## REVISION TRANSMITTAL

This sheet transmits Revision 1 to SL680-30-09, which:

ICE AND RAIN PROTECTION - ADD SEALANT BETWEEN PICCOLO TUBES AND LANDING LIGHT BOX FASTENERS TO PREVENT CHAFING

SL680-30-09  
Page 1 of 10

Figure 1. Sealing Between Piccolo Tubes And Light Box Fasteners (Sheet 1)

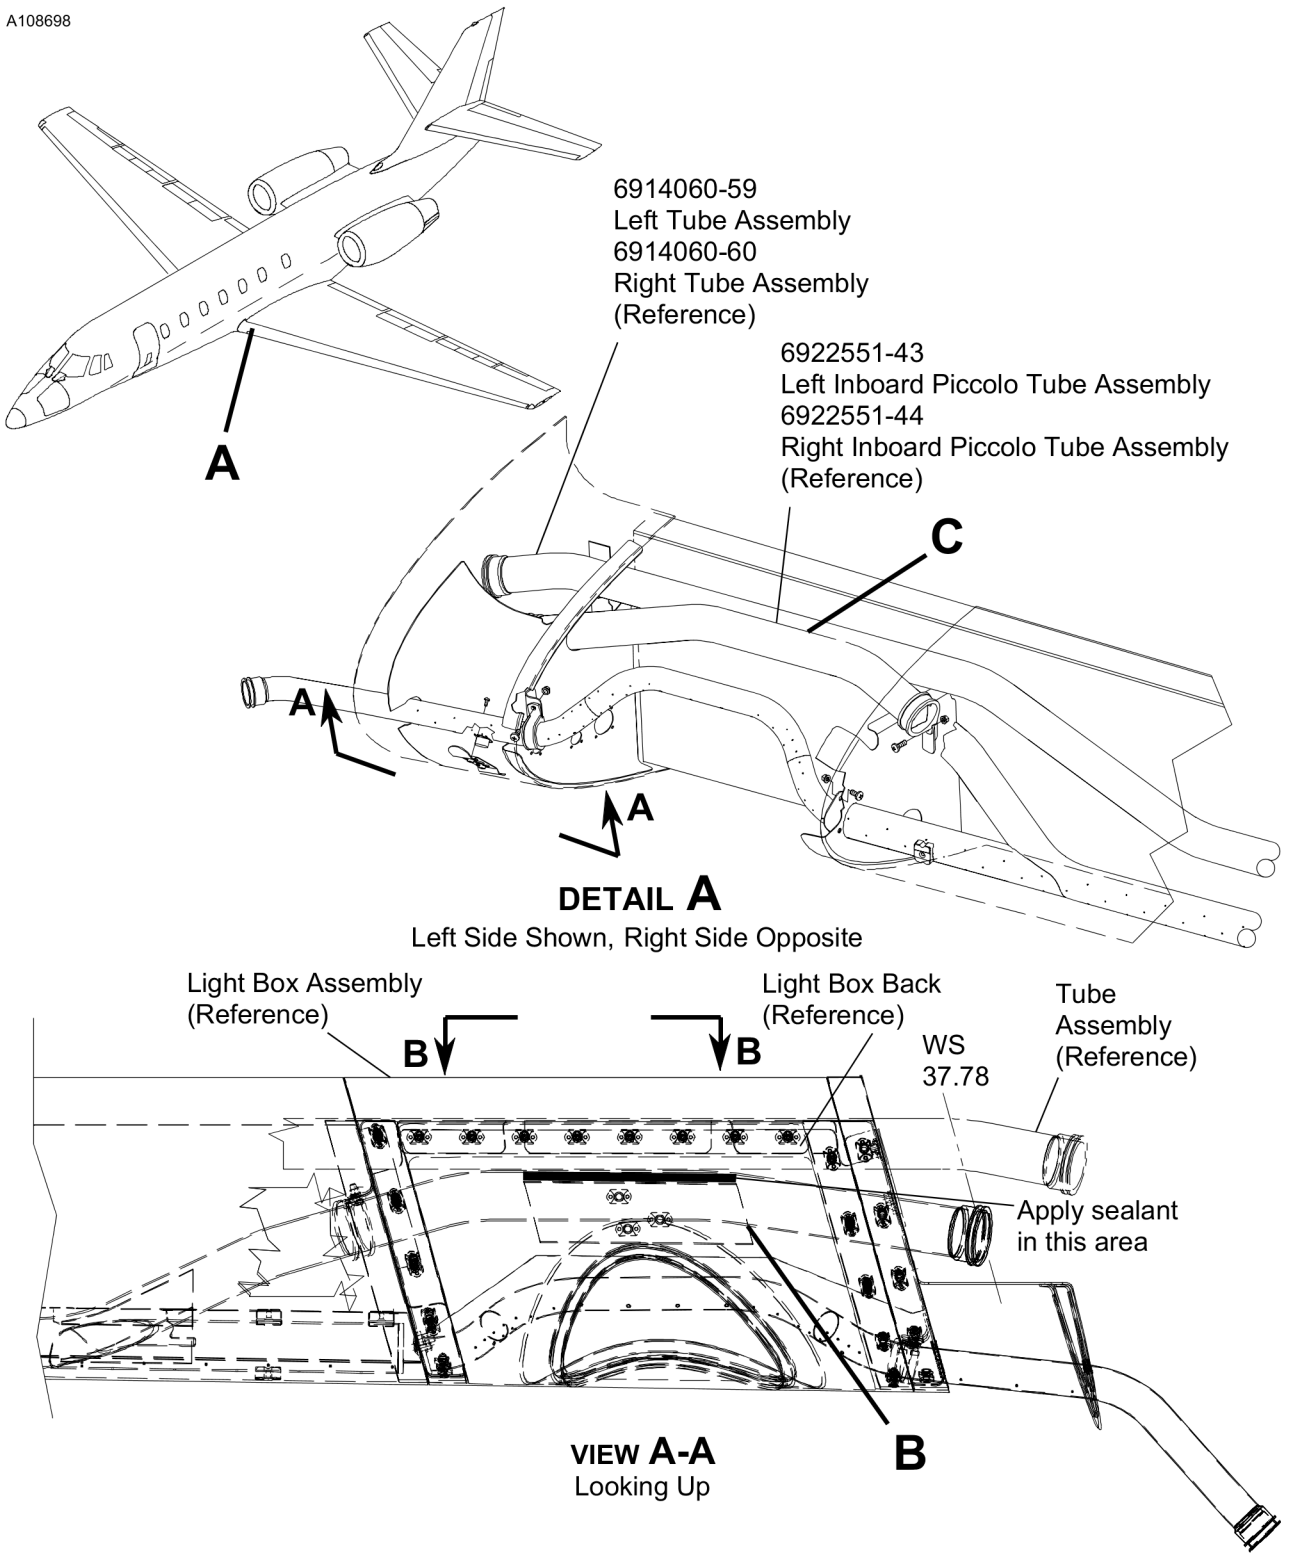
- A. Adds Step 2 to remove access panels 165AL and 166AR.
- B. Adds Step 3 to inspect for chafing between the tube assemblies and replace them, if necessary.
- C. Adds Step 5 to remove the top doubler.
- D. Adds Step 4.B.1.(2) to allow the sealant to cure for 24 hours.
- E. Adds Step 5 to install the top doubler.
- F. Adds Step 6 to install the landing light.
- G. Adds Step 7.A to allow the sealant to cure for 24 hours.
- H. Adds Step 8 to install access panels 153BL and 154BR.
- I. Adds Figure 1, Sheet 3 which shows removal and installation of the top doubler.
- J. Adds Figure 1, Sheet 4 and Sheet 5 to show assembly of the inboard and outboard Tube Weld Assemblies.
- K. Adds the table to the MATERIAL INFORMATION section.

- (a) Allow the sealant to cure for 24 hours.
  - (6) Go to Step 5.
4. (Refer to Figure 1, Detail A, View A-A and View B-B.) Inspect for sealant between the 6914060-59 Left, 6914060-60 Right Tube Assembly and the 6922551-43 Left, 6922551-44 Right Inboard Piccolo Tube Assembly where the tubes come together above the light box assembly.

- (1) (Refer to Figure 1, Detail A, View A-A and View B-B.) Fillet seal between the 6914060-59 Left, 6914060-60 Right Tube Assembly and the 6922551-43 Left, 6922551-44 Right Inboard Piccolo Tube Assembly with U065013S (Type V, Class B) Sealer. (Refer to the Citation Standard Practices Manual, Chapter 20, Fuel, Weather, Pressure and High Temperature Sealing - Maintenance Practices.)

7. (Refer to Figure 1, Detail A, and View A-A .) Fillet seal between the fasteners on top of the Light Box Back and the 6922551-43 Left, 6922551-44 Right Inboard Piccolo Tube Assembly.) with U065013S (Type V,

Figure 1. Sealing Between Piccolo Tubes And Light Box Fasteners (Sheet 2)

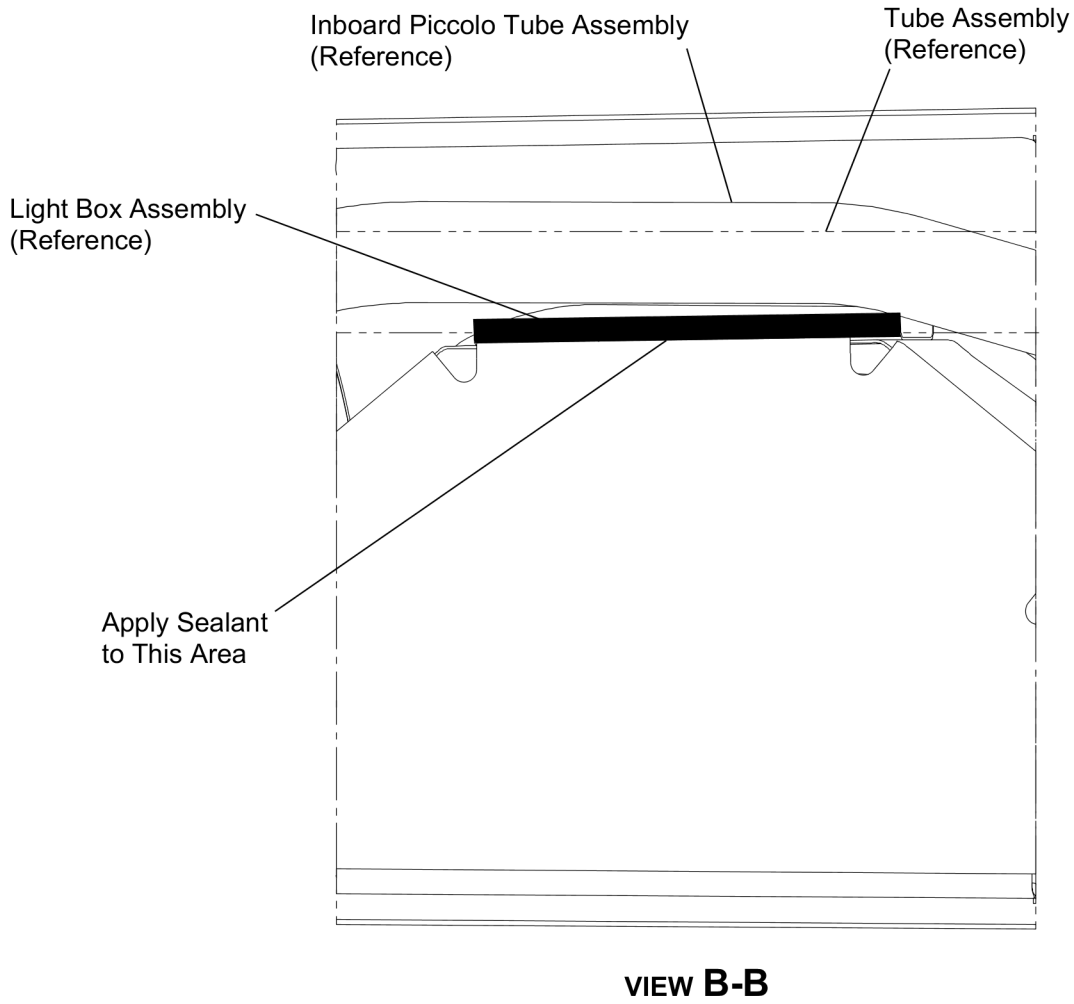
- (2) Remove and keep the screws.
    - (3) Remove and keep the top doubler.
  - D. (Refer to Figure 1, View A-A.) Inspect the 6914060-59 Left, 6914060-60 Right Tube Assembly and the 6922551-43 Left, 6922551-44 Right Inboard Piccolo Tube Assembly.

- (5) (Refer to Figure to Figure 1, Detail A, Detail B and View A-A.) Fillet seal between the replaced piccolo tubes or tube assemblies with U065013S (Type V, Class B) Sealant. (Refer to the Citation Standard Practices Manual, Chapter 20, Fuel, Weather, Pressure and High Temperature Sealing - Maintenance Practices.)

**DETAIL B**  
Left Side Shown,  
Right Side Typical

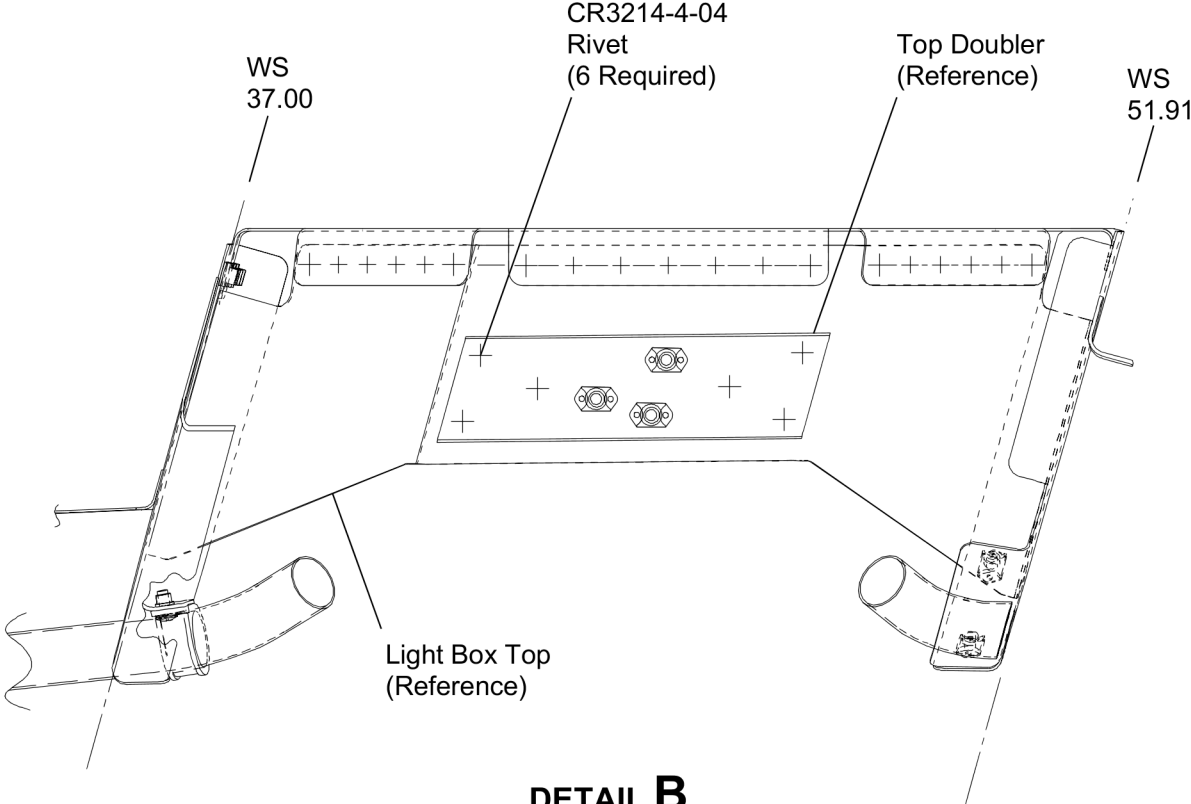
- C. (Refer to Figure 1, Detail B.) Remove the left and right top doubler.
    - (1) Remove and discard the rivets from the top doubler. (Refer to the 680 Structural Repair Manual, Chapter 51, Fastener Installation and Removal.)

- (2) Allow the sealant to cure for 24 hours.
  - C. Go to Step 5.
5. (Refer to Figure 1, Detail A, Detail B and View A-A.) Install the left and right top doubler.

- A. Put the top doubler on the light box top.
  - B. Attach the top doubler to the light box top with the kept screws and 6 CR3214-4-04 Rivets.
6. Install the left and right landing light. (Refer the Model 680 Maintenance Manual, Chapter 33, Landing Light - Removal/Installation.)

Figure 1. Sealing Between Piccolo Tubes And Light Box Fasteners (Sheet 4)

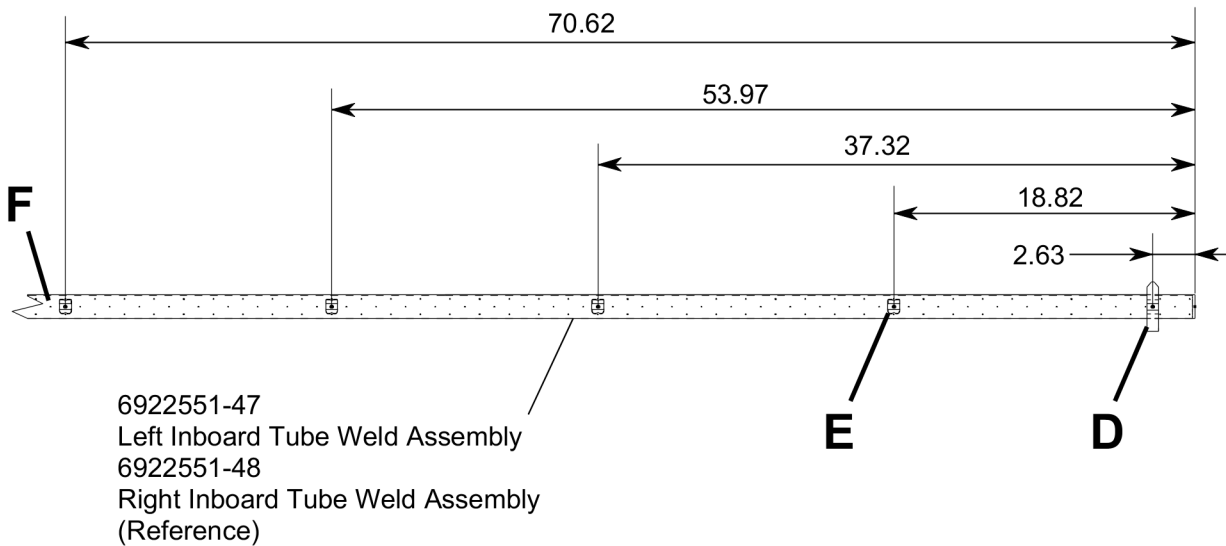
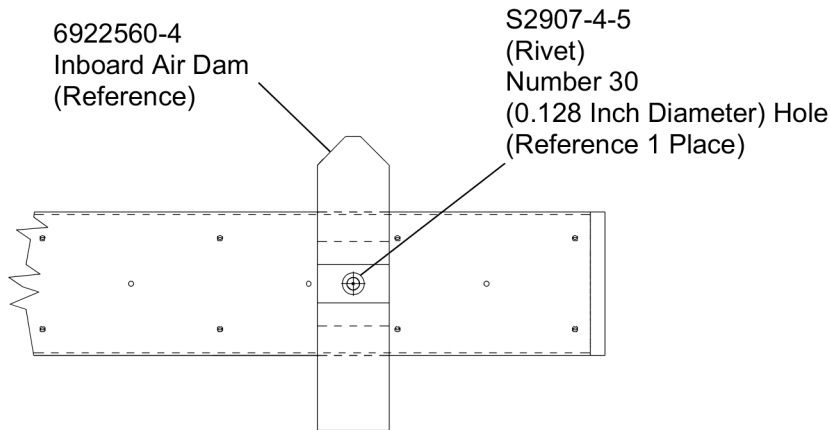
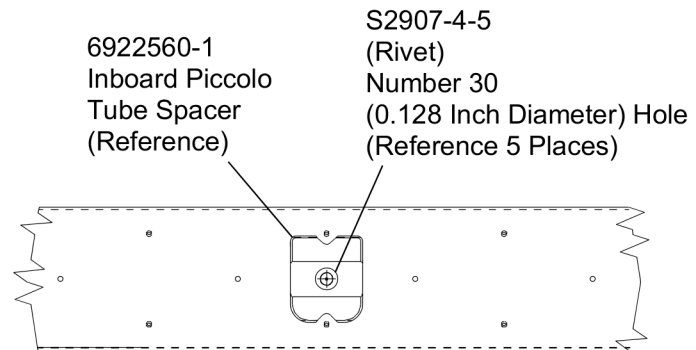
- (3) (Refer to Figure 1, Detail A, Detail C, Detail D, Detail E and Detail F.) If necessary, assemble the 6922551-43 Left, 6922551-44 Right Inboard Piccolo Tube Assemblies.

- (a) Put the five 6922560-1 Tube Spacers on each 6922551-47 Left, 6922551-48 Right Inboard Tube Weld Assemblies.
      - 1 Drill one Number 30 (0.128 inch-diameter) hole in each 6922560-1 Tube Spacer.

- (b) Put the two 6922560-4 Inboard Air Dams on each 6922551-47 Left, 6922551-48 Right Inboard Tube Weld Assemblies.
      - 1 Drill one Number 30 (0.128 inch-diameter) hole in each 6922560-4 Inboard Air Dam.

- (c) Remove the 6922560-1 Tube Spacers and 6922560-4 Inboard Air Dams from the 6922551-47 Left, 6922551-48 Right Inboard Tube Weld Assemblies.
    - (d) Deburr the holes that were drilled.

- (e) Attach the 6922560-1 Tube Spacers and 6922560-4 Inboard Air Dams to each 6922551-47 Left, 6922551-48 Right Inboard Tube Weld Assemblies with one S2907-4-5 Rivet.
